AR8600 Mark2 ADDENDUM (paperwork V1.0)

Due to continuous development of our products, the AR8600 has been enhanced in several areas. The upper frequency range has been extended to 3.0GHz (3000MHz), lower band sensitivity has been increased (now officially covering to 100kHz) with an enhancement to short wave performance by the addition of further bandpass filters and selection of alternative I.F. filters. Mini-Circuits RMS1 / RMS2 mixers have been employed with active SPM aerial switching devices (not diode-switching) abundantly employed throughout the signal path. The AR8600 Mark2 provides remarkable short wave performance, making other similar wide band competitors mediocre by comparison. However daily operation of the AR8600 Mark2 is largely unaffected, just a few operational changes need be noted.

LAMP DIMMER

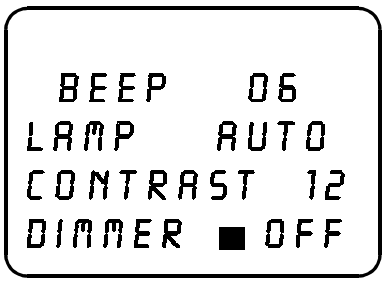
There are now effectively three states of LAMP, lamp off / lamp on / dimmer on. While the lamp is bright for daily operation, in areas of permanent low lighting, it is nice to dim the lamp. An additional line has been added to the CONFIG MENU, 'DIMMER' with a value of OFF or ON, the default is OFF. To access the CONFIG menu PUSH☞ (FUNC) PUSH☞ (7 GQ). The first item in the config menu is "BEEP". PUSH☞ ⇩to move the cursor to the line marked "DIMMER". Use the main dial or ⇦ ⇨ keys to toggle the DIMMER ON / OFF. The (PASS) key may be used as a short cut to OFF.

PUSH☞ (ENT) to accept the data and return to a standard display. Alternatively PUSH☞ (CLEAR) to abort entry or PUSH☞ ⇩ to move to the next item on the config menu. Refer to pages 106 - 107 of the operating manual.
